Final Reclamation Inspection

Operator: PDC ENERGY INC - 69175

Location ID: 320417

Inspection Photos
Location Name: MCELWAIN #41-17
Location ID: 320417

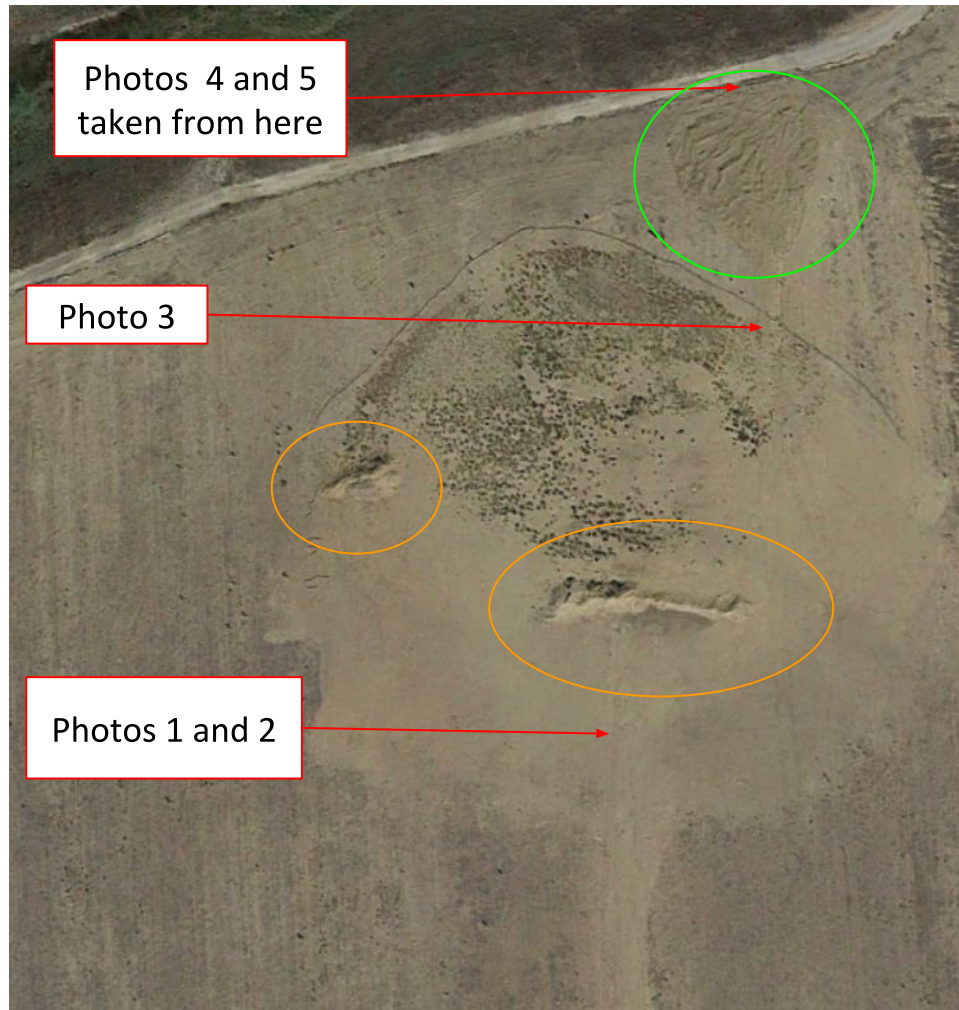
Photo 6. Google Earth aerial imagery taken 9/12/2019 during ongoing remediation efforts. At the time of this inspection, the soil stockpiles (orange circle) still remain in addition to the northern disturbance area (green circle). Imagery also illustrates where approximate photos were taken from during this inspection.
